Inspection Photos

Operator: TEP Rocky Mountain LLC #96850

Location ID: 323944

Inspection Doc: 719200280

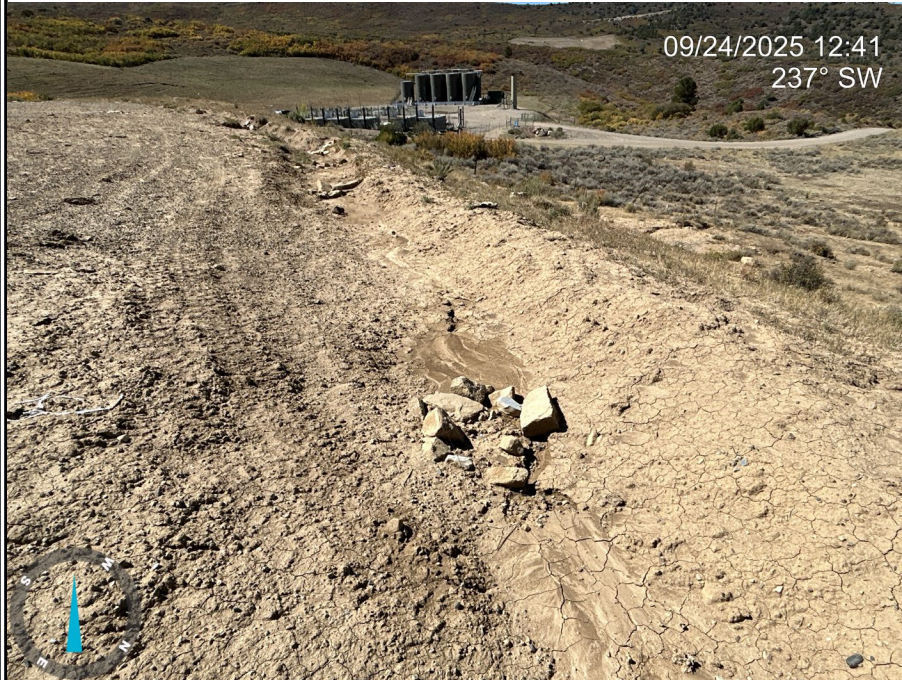
Photo 3: Photos showing stormwater controls on the northern portion of the location appear to be in disrepair. Sediment migration and rilling is evident. Stormwater BMPs do not appear to be constructed per good engineering practices. Comply with 1002.f. and implement and/or maintain stormwater BMPs.
